Office Action Summary	Application No. 10/561,972	Applicant(s) WENGER, KLAUS HERBERT GUNTER	
	Examiner EVAN DZIERZYNSKI	Art Unit 2875

DETAILED ACTION

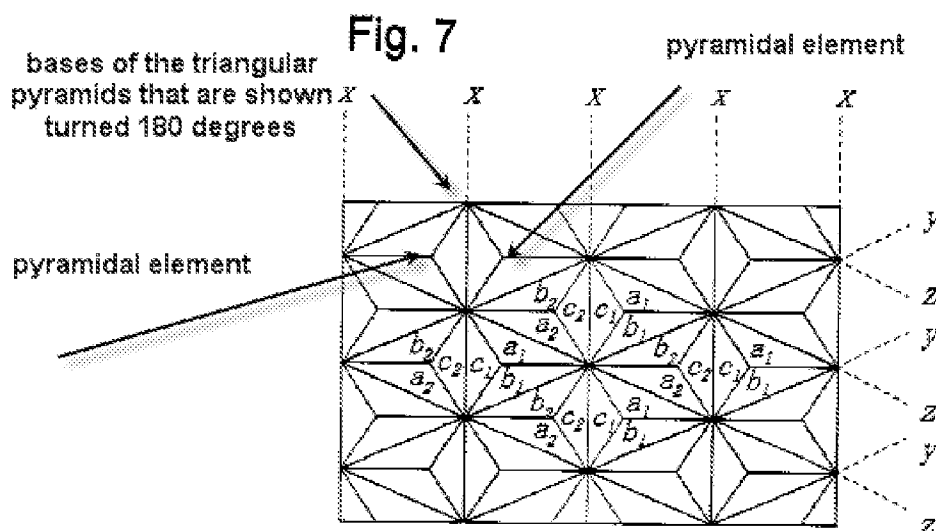
As for claim 19, Mimura discloses optically refractive pyramidal elements (paragraph 0009), each having a triangular base (Fig 7), such that the bases of adjacent elements are turned 180 degrees relative to each other (as indicated below), the pyramidal elements have respective apex angles configured to provide a desired optical refraction (paragraph 0009, Fig 7).

As for claim 20, Mimura shows that the bases are divided into adjacent rows (Fig 7, vertically, from left to right), with the bases of the elements of adjacent rows being turned through 180 degrees relative to each other.
